Chevron appreciates the opportunity to respond to the questions raised in the Air Resources Board whitepaper *Staff's Preliminary Assessment of the Need for Clarification for the Reporting of Covered Product Data for Petroleum and Natural Gas* dated December 11, 2015. The white paper introduces a number of questions regarding reporting covered product data and ARB's assessment that variability exists in the reporting and metering methods used for thermal enhanced oil recovery (EOR) and non-thermal EOR covered product data under its Mandatory Reporting Regulation as required by the California Global Warming Solutions Act.

Attachment 1: Detailed Comments on the ARB Upstream Reporting White Paper

Reservoir Management in the Duri Steamflood

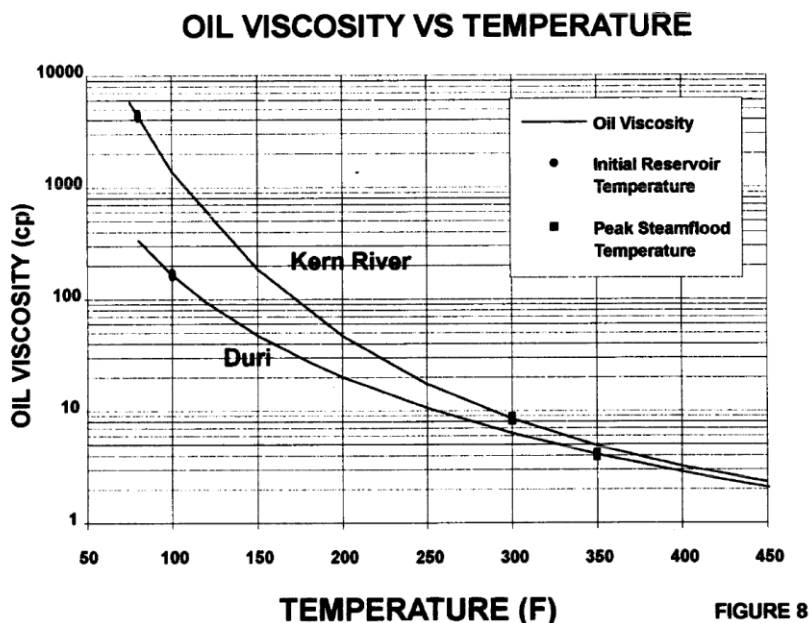
While Chevron supports continued use of ARB’s current definition of “thermal enhanced oil recovery” as the process of using injected steam to increase oil recovery, guidance can be further clarified by recognizing the injected steam’s function and purpose, which is to introduce heat. The added heat reduces the viscosity of the crude, making it easier to bring it to the surface.
